PUBLIC UTILITIES COMMISSION

October 6, 2014

RE: Request for Additional Data #2 – Certificate of Public Convenience and Necessity for the Sycamore-Peñasquitos 230-Kilovolt Transmission Line Project – Application No. A. 14-04-011

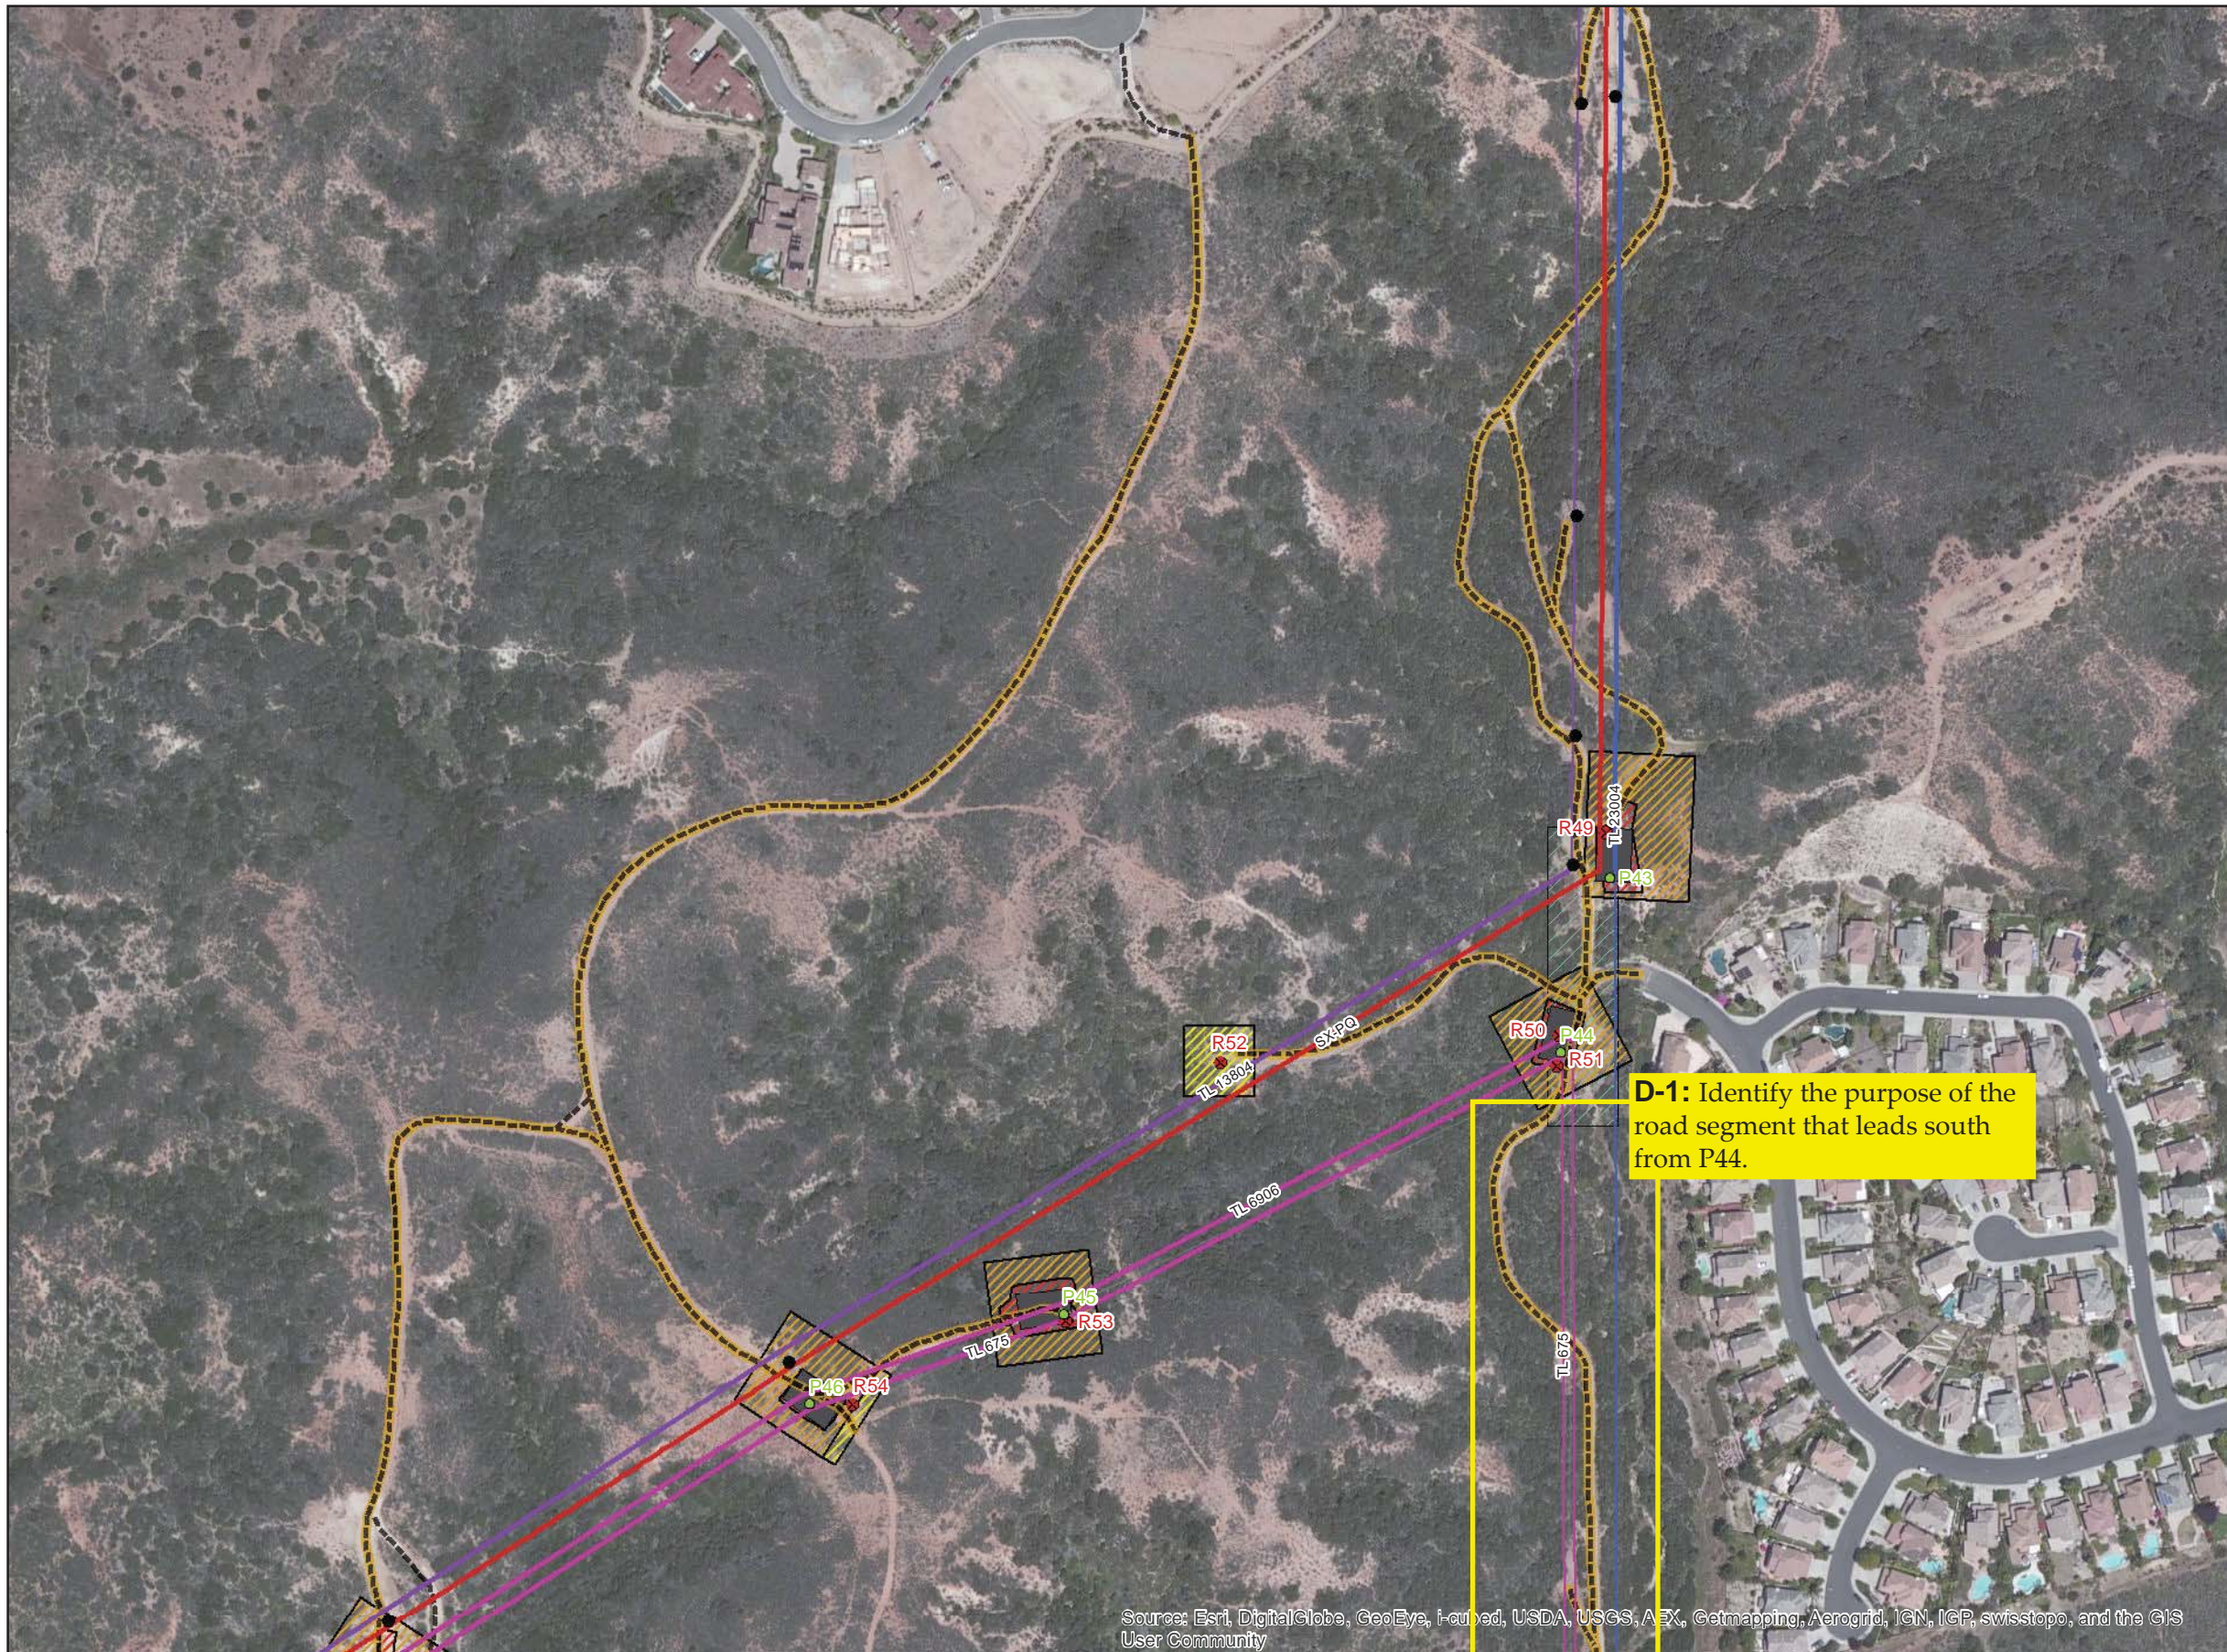
D-3: Identify the purpose of the road segment south of P49. Clarify if the area along the road segment would be used during construction.

D-4: Identify the purpose of the road segment that leads southeast from P50.

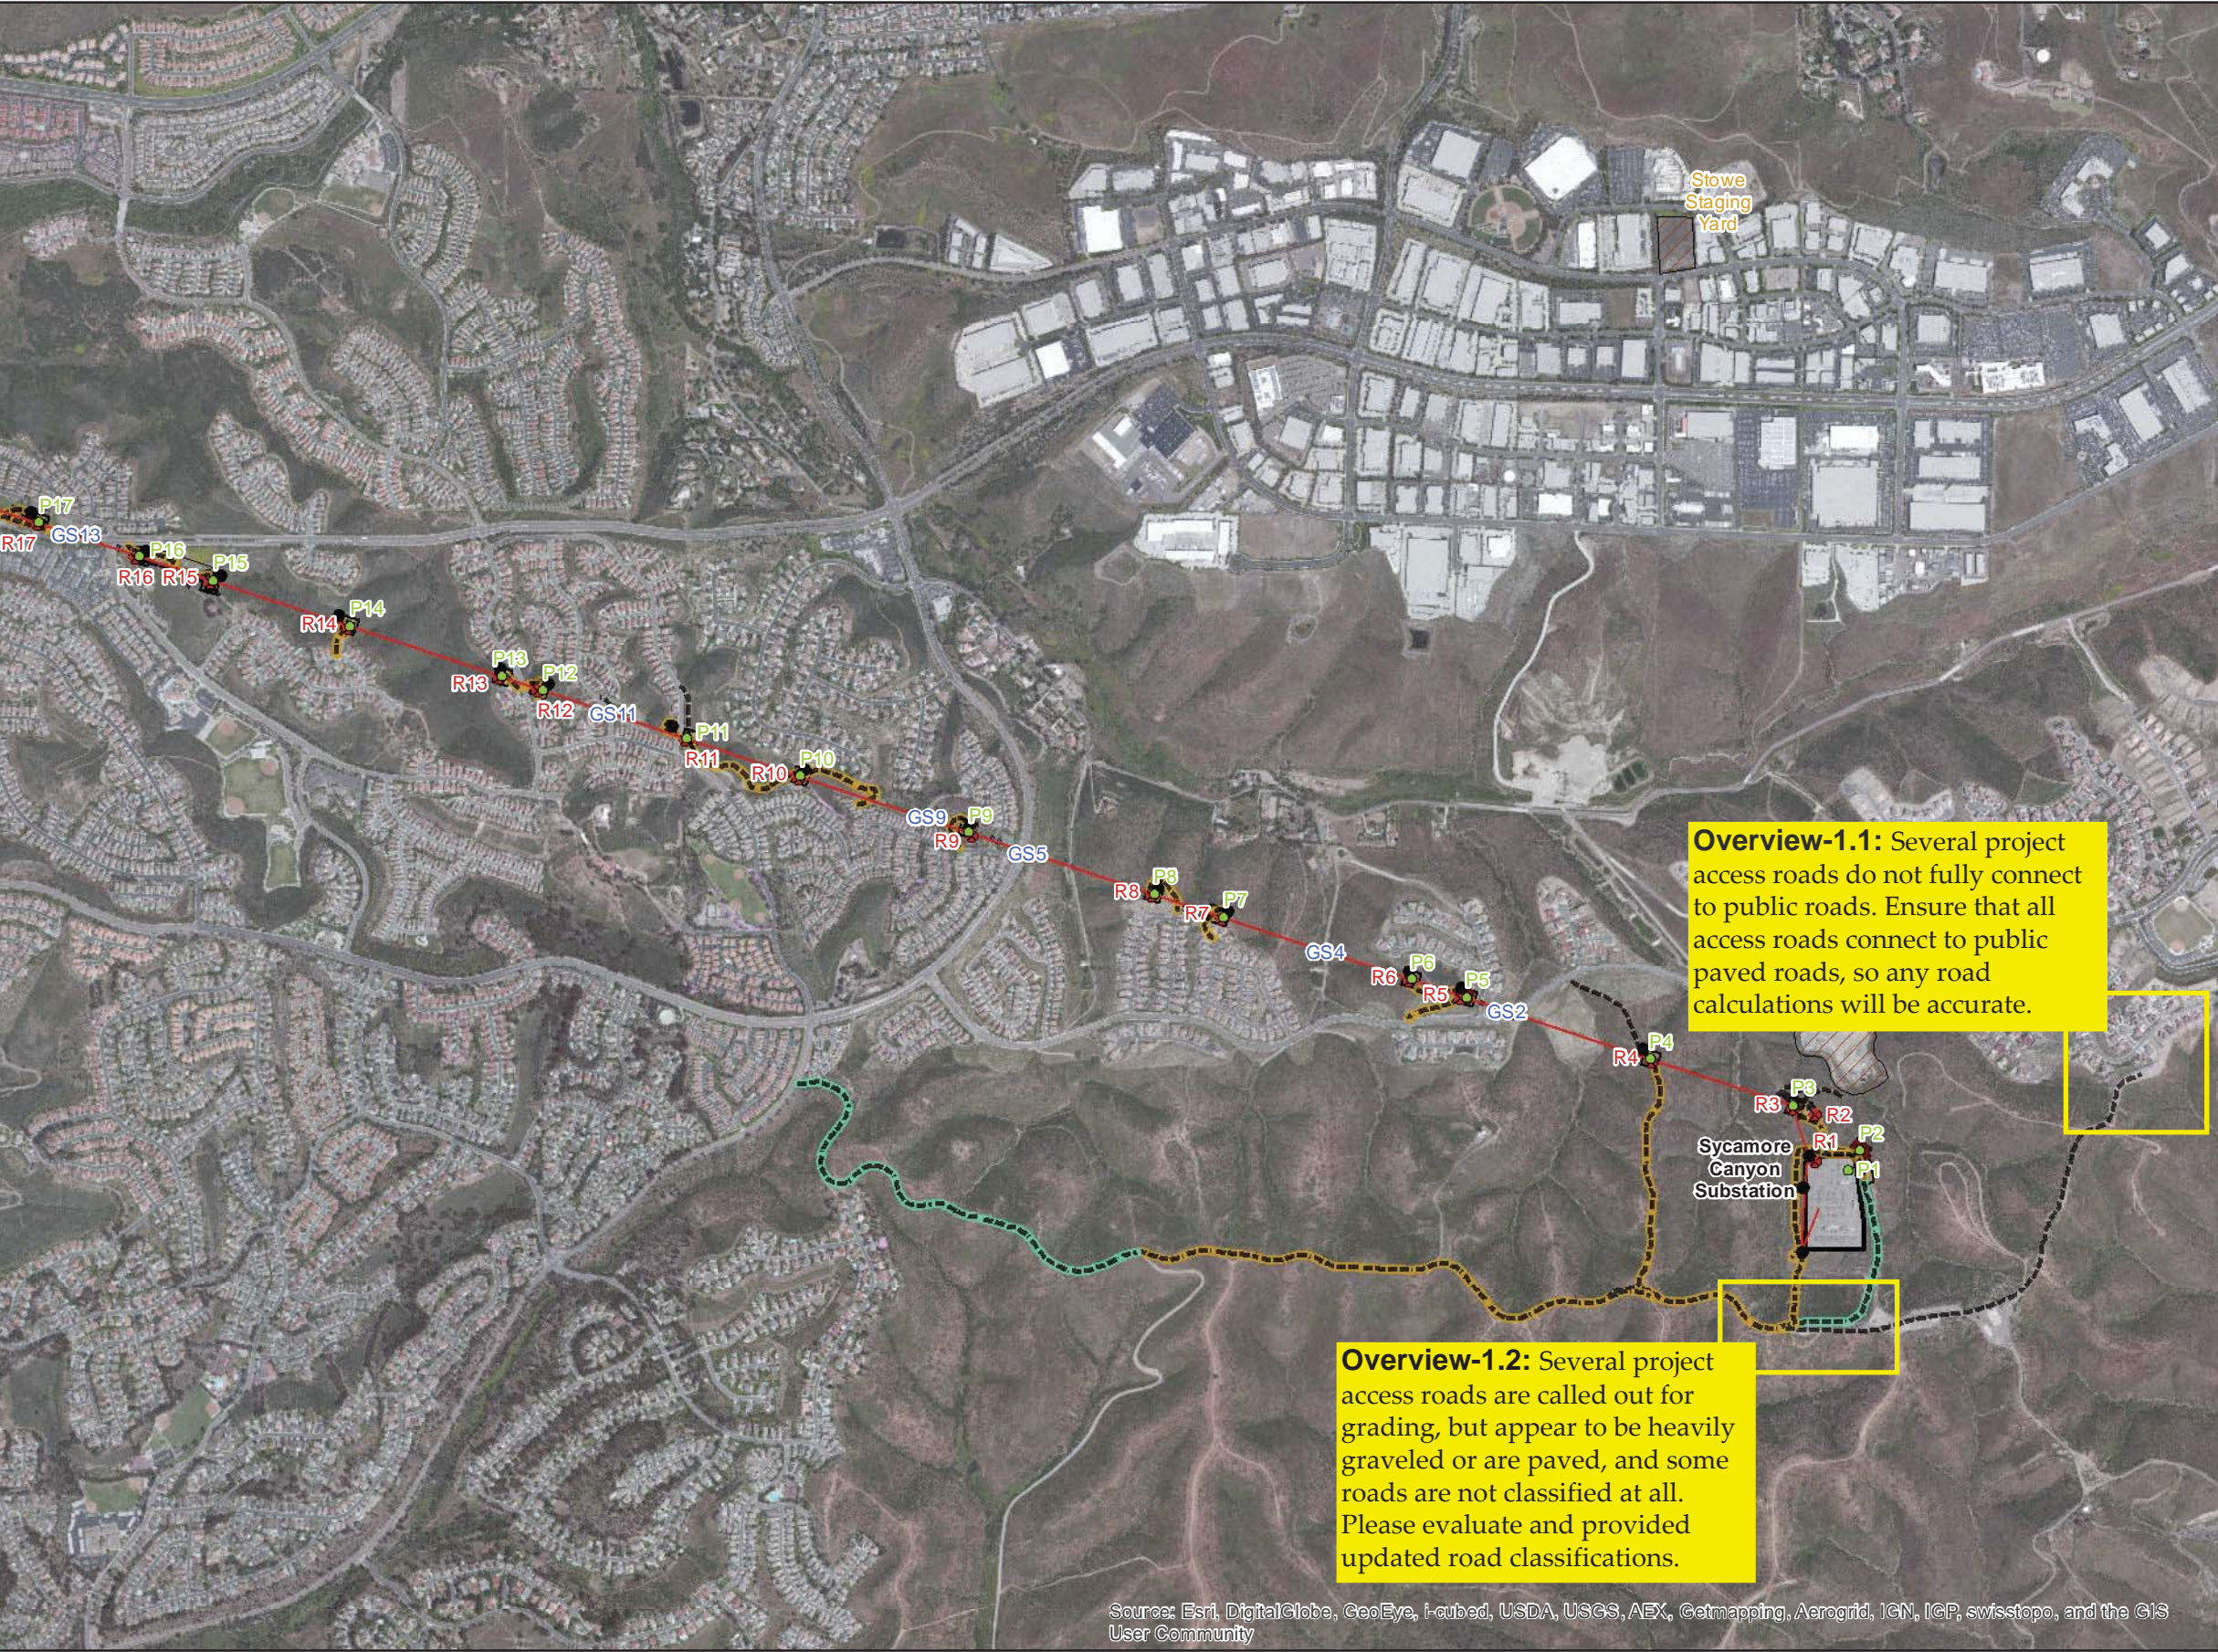
Overview-2: The long access route west of Segment A (near P20 through P23) does not connect to any work areas. State the purpose for this access road.
